**STATE ENVIRONMENTAL POLICY ACT
DETERMINATION OF NONSIGNIFICANCE (DNS)
KIMBALL ELEMENTARY SCHOOL REPLACEMENT PROJECT**

Date of reissuance: Dec. 10, 2020
Lead agency: Seattle Public Schools
Location of proposal: Kimball Elementary School, 3200 23rd Ave. S, Seattle, WA
(Section 16, Township 24N, Range 4E)

Kimball Elementary New Replacement Project

DETERMINATION OF NONSIGNIFICANCE (DNS)

Figure 3a. Tree Removal Plan - South

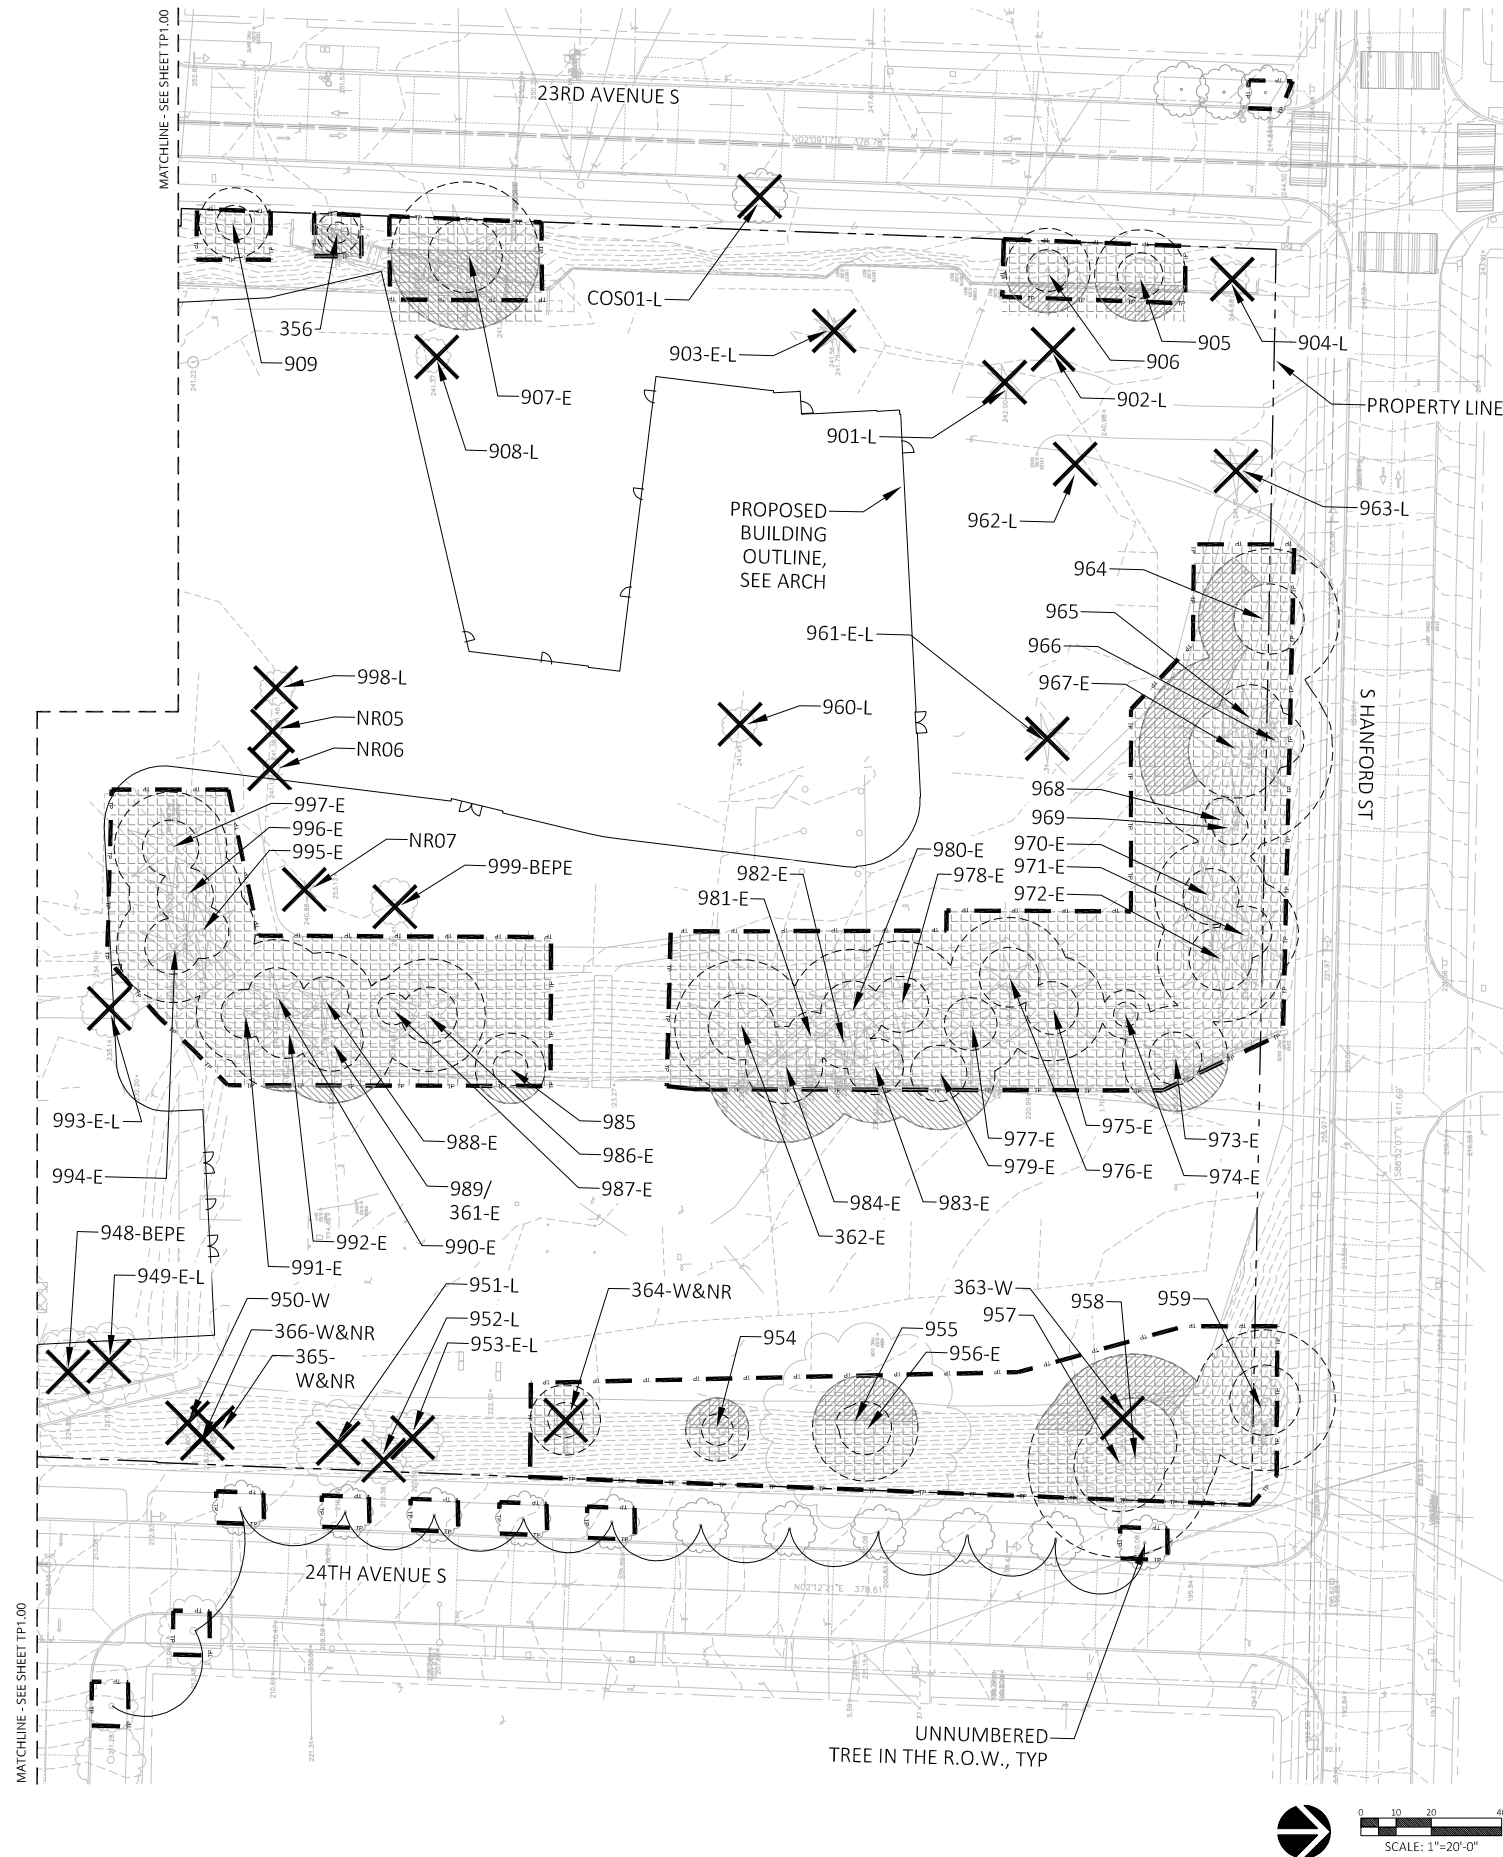
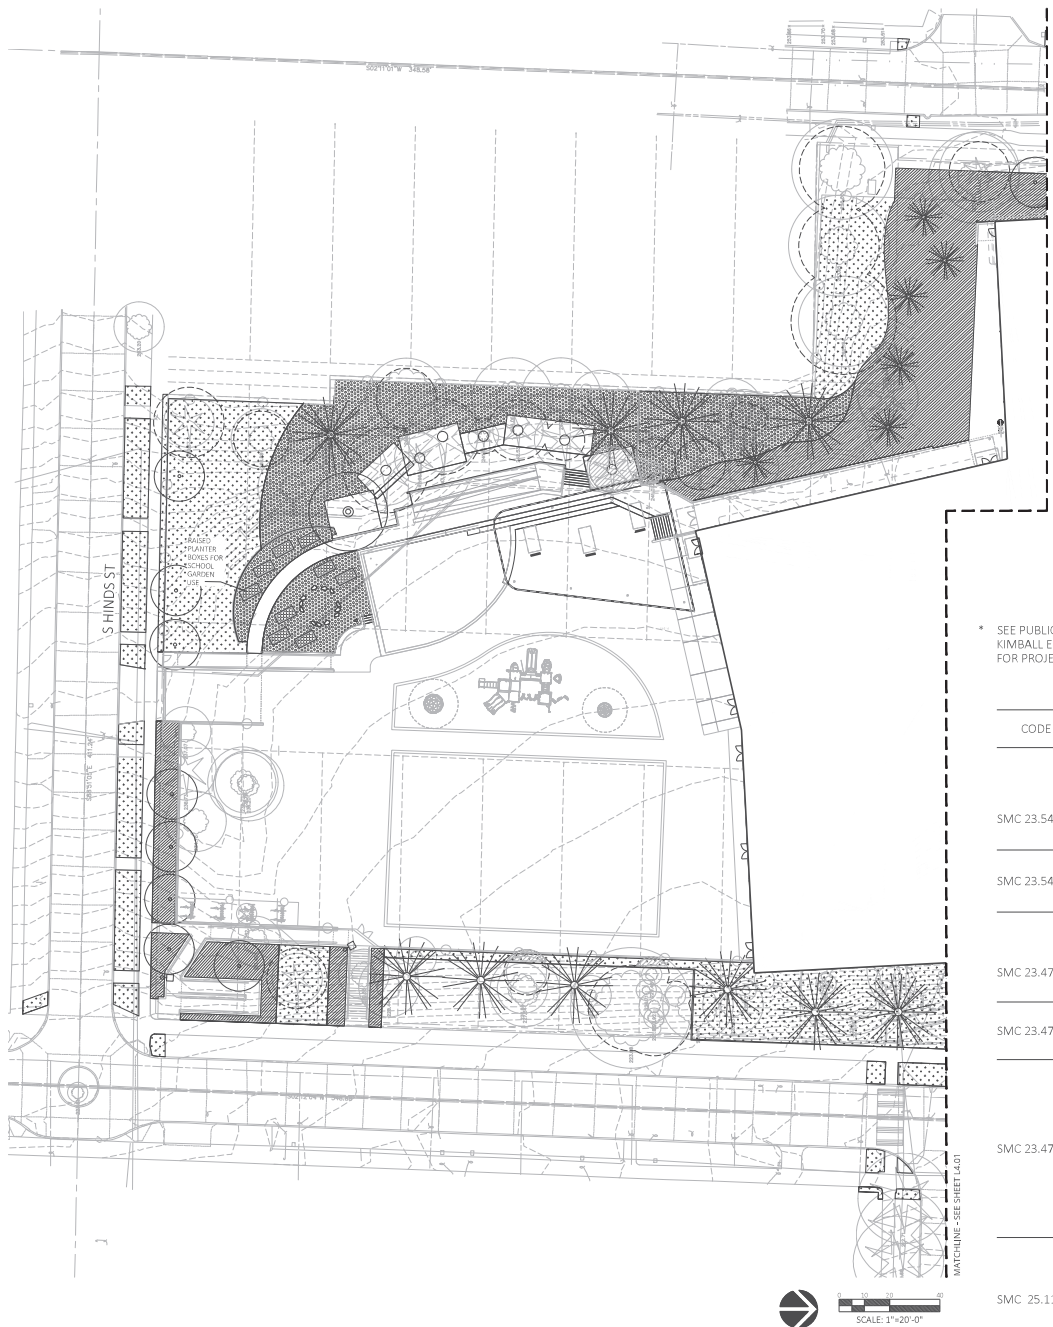
7. Plants. Important trees and plants are at risk from the project. Will more trees be planted to replaced trees that would be removed? [Commenters Jackins, Wong]

The school was designed to avoid impacts to exceptional trees and groves to the extent practicable. Sixty-two trees (including one off-site), are proposed for removal due to health, weed status, or location including 18 smaller than 6 inches' caliper that are not regulated under SMC 25.11. Six of the trees proposed for removal are exceptional trees. These trees will be replaced in accordance with SMC 25.11.090. The grove areas would be retained and enhanced. SPS proposes to plant 91 new trees on-site. Non-native and invasive understory species will be cleared from within the exceptional tree groves.
